NOTE:
1. REVISION NO. 1 REFLECTS THE NEW ALIGNMENT OF TAXIWAY F3 168.75' NORTH OF ORIGINAL DESIGN. BID QUNTITIES ARE BASE ON THIS NEW ALIGNMENT.
2. CONFORMED PLAN SET SHALL SHOW THIS NEW ALIGNMENT OF TAXIWAY F3 PROVIDED THE ADDITIVE ALTERNATE NO. 1 IS ACCEPTED.

BATON ROUGE METROPOLITAN AIRPORT
FOXTROT TAXIWAY EXTENSION
BATON ROUGE, LA

LIGHTING & SIGN LAYOUT – ADDENDUM 2

The following items are issued to add, modify, and clarify the Contract Documents and Specifications. These items shall have full force and effect, as the contract Documents and the cost involved shall be included in the bid prices.

1 AIRFIELD ELECTRICAL VAULT LAYOUT MODIFICATIONS

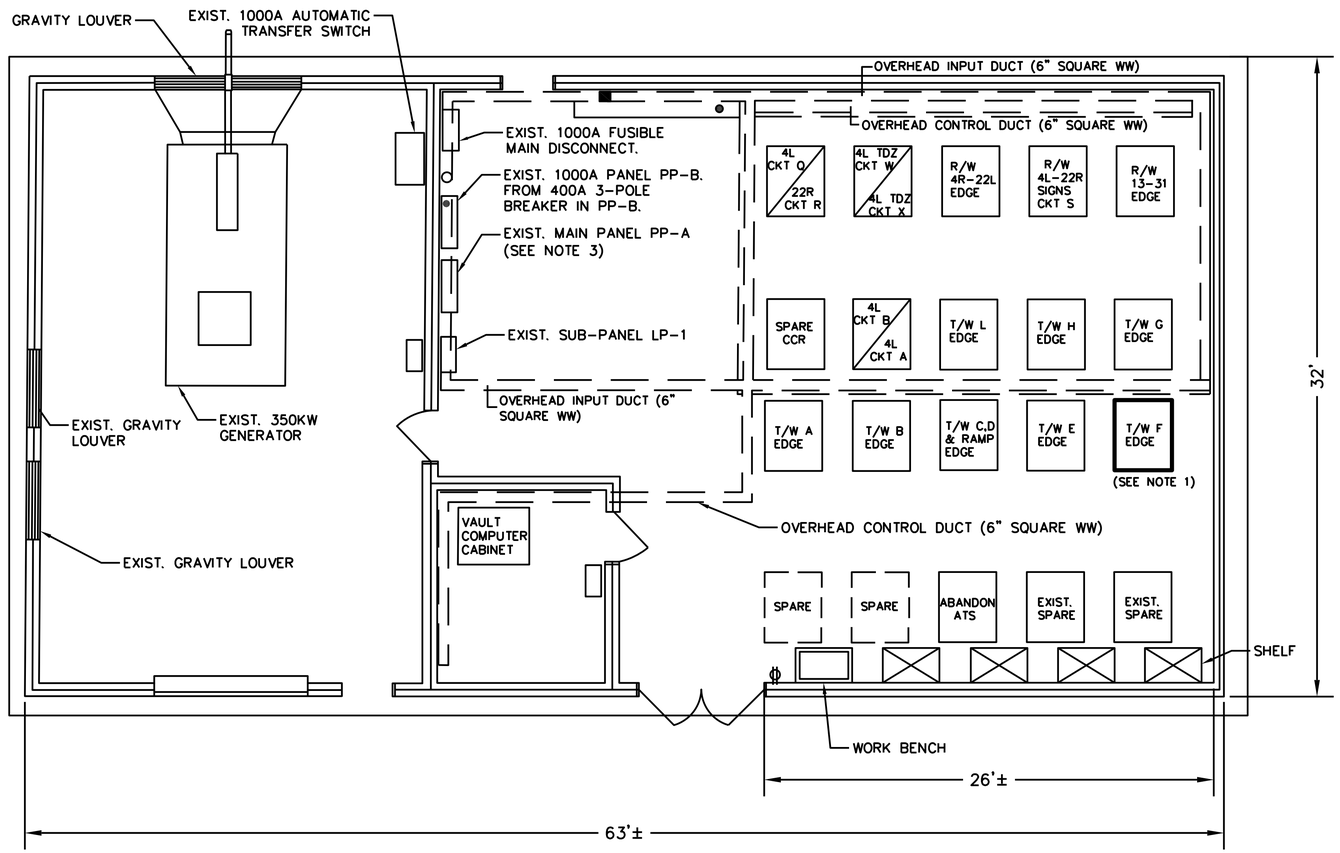
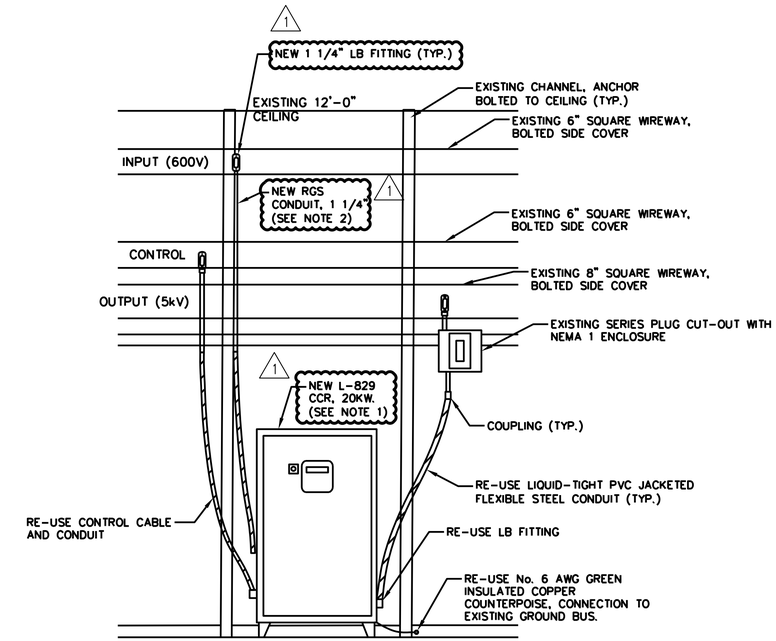
NO.	REVISIONS	DSGN	CHKD	APVD	DATE
1	REVISED REGULATOR	BTP	VLM	VLM	07/08/16

1. PROVIDE A NEW 20KW L-829 3-STEP, 6.6 AMPERE, FERRORESONANT AIR-COOLED DRY-TYPE CONSTANT CURRENT REGULATOR FOR A 240-VOLTS, 60-HERTZ SUPPLY AND 120-VOLTS CONTROL. THE REGULATOR SHALL BE ADB CSF6620-325A AS DESCRIBED IN FAA AC 150/5345-10H. DELIVER EXISTING FOXTROT REGULATOR TO THE AIRPORT FOR USE AS A SPARE.
2. PROVIDE NEW 1.25-INCH CONDUIT FROM POWER CABLE WIREWAY AND 2 #1/0 (AB), 1 #6 (G) THWN-2 CONDUCTORS FROM PANEL PP-A.
3. PROVIDE NEW SQUARE-D 2P150A CIRCUIT BREAKER IN PANEL PP-A FOR BRANCH CIRCUIT TO NEW TAXIWAY FOXTROT CONSTANT CURRENT REGULATOR.
